Access Compliance Report

Public Rights-of-Way

(Curb Ramps)

Intersection ID: 10077	Main Street: E_35TH_ST	Cross Street: N_DAVIDSON_ST	Location: SW
ADA ID: 7968CD0CFC2C	Ramp Type: BlendTrans2	Initial Pass/Fail: Pass	Overall Compliance: No
		Severity Score: 7.5	
Codes/Mitigation Info/Possible Solution		Field Measurements/Component Compliance

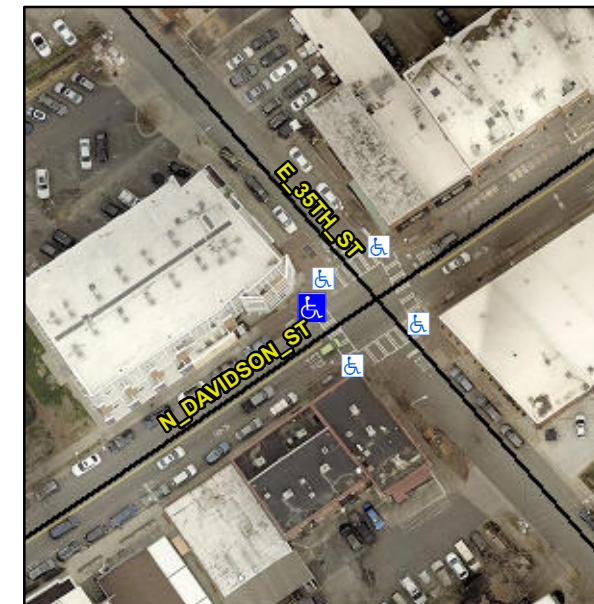
R304.2.3, R302.7.2

Remove & Replace Curb Ramp With Two New Directional Ramps or Equivalent. Grind Gutter Lip.
